GREEN LAKE COUNTY

Highway & Highway AdHoc Joint Committee Meeting

Re: Green Lake County Highway Facility
 Princeton, WI 54968
Project: 240830

Reference Document: PCI0012

SHEET NUMBER
P1.1B

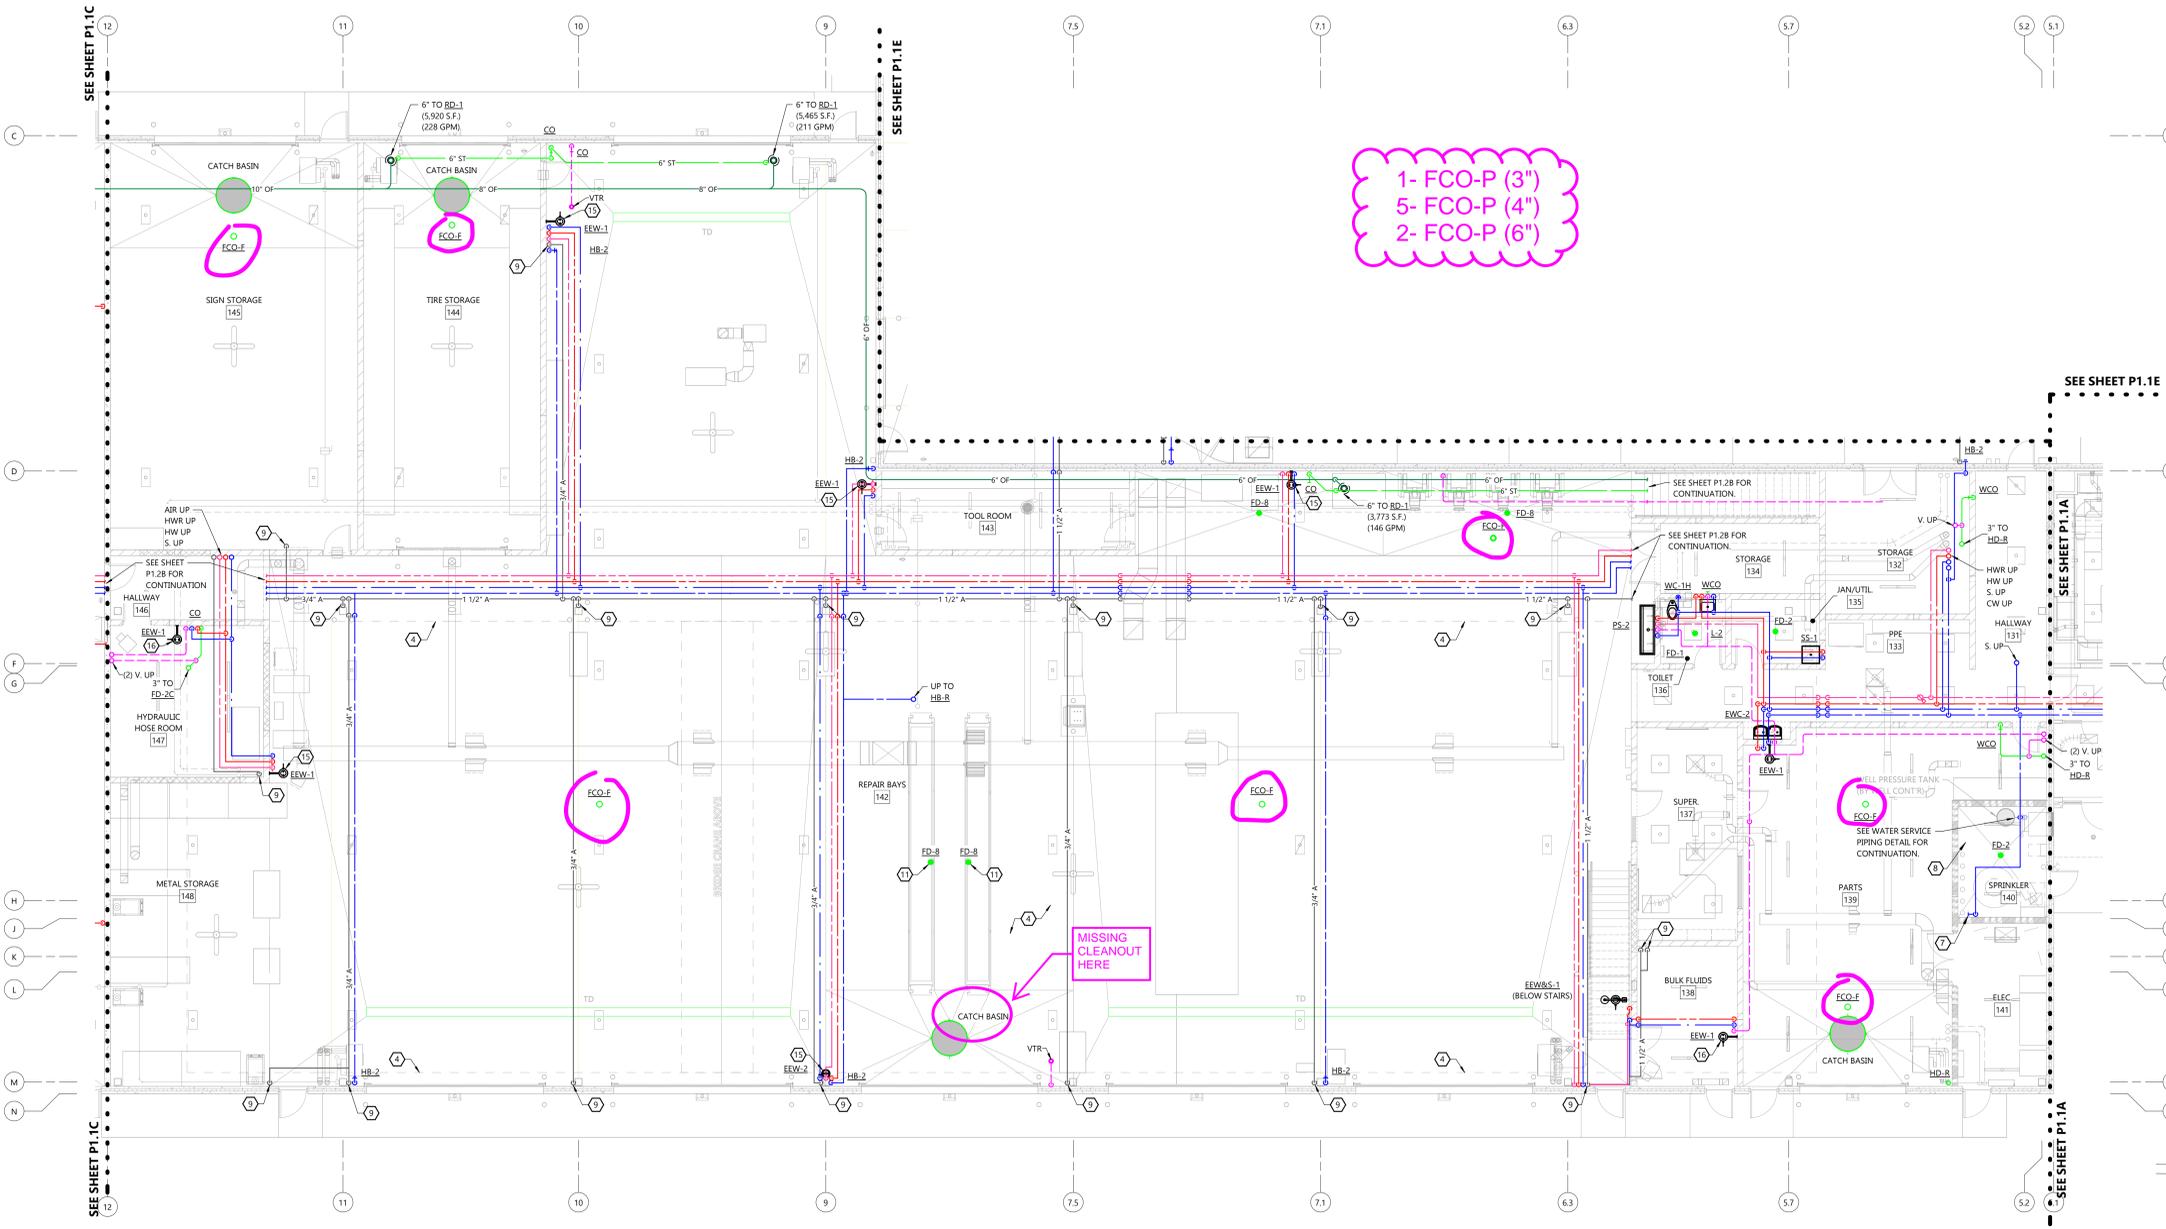
Change Description: Change Cleanout To Stainless Steel - Per direction from Excel, provide pricing to change out (26) cleanouts in all truck areas (see attached drawing for locations), from original specification to stainless steel.

MISSING CLEANOUT HERE

PROJECT NAME	Green Lake County Highway Facility
OWNERS PROJECT NUMBER	240830
HOOPER JOB NUMBER	26112008
DATE	2/16/2026
CB OR CHANGE NUMBER	
DESCRIPTION	Owner request to provide stainless-steel heavy-duty floor cleanouts in all truck areas
